VILLAGE OF ARLINGTON HEIGHTS

Subject: Staff Development Committee - Tots Land Daycare at 1007 W. Euclid Ave.

To: Planning Staff Liaison
From: Nanci Julius, P.E., Senior Civil Engineer
Department: Public Works Department, Engineering Division
File Number: PCA00005-2024
Project: 1007 W Euclid Ave Day Care
Review Round: Round 1
Date: April 25, 2024

Project: Tots Land Day Care Center Special Use Permit
1007 W Euclid Ave

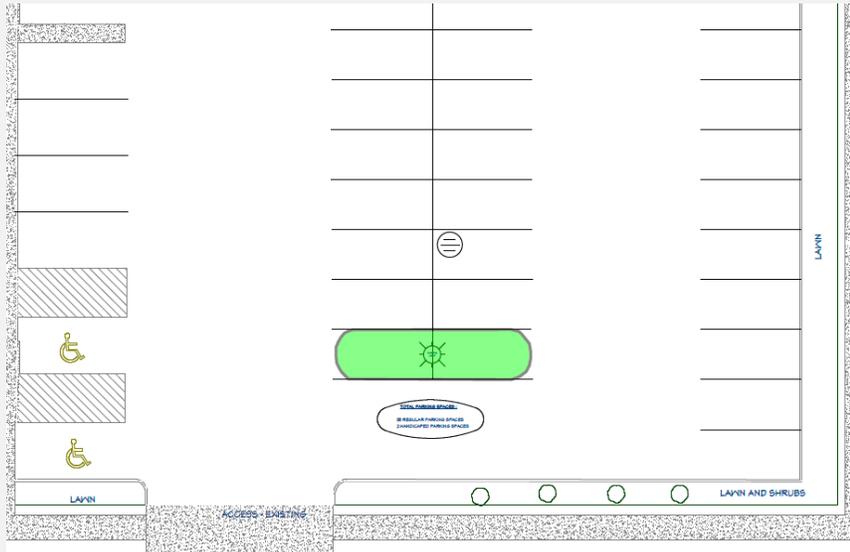
25. Please confirm that the outdoor play areas will not include any noise making devices (bells, wind chimes, etc.).
26. Would any of the outdoor play areas include shade structures/sun screens/awnings/canopies? If so, these elements must be shown on the plans and details must be provided on the height, size, material, etc.
27. A curbed landscape island is required beneath all light poles, which shall include a shade tree at each end. Additionally, a curbed landscape island is required at the termination of the western parking row. Please add the code required landscape island as shown below:
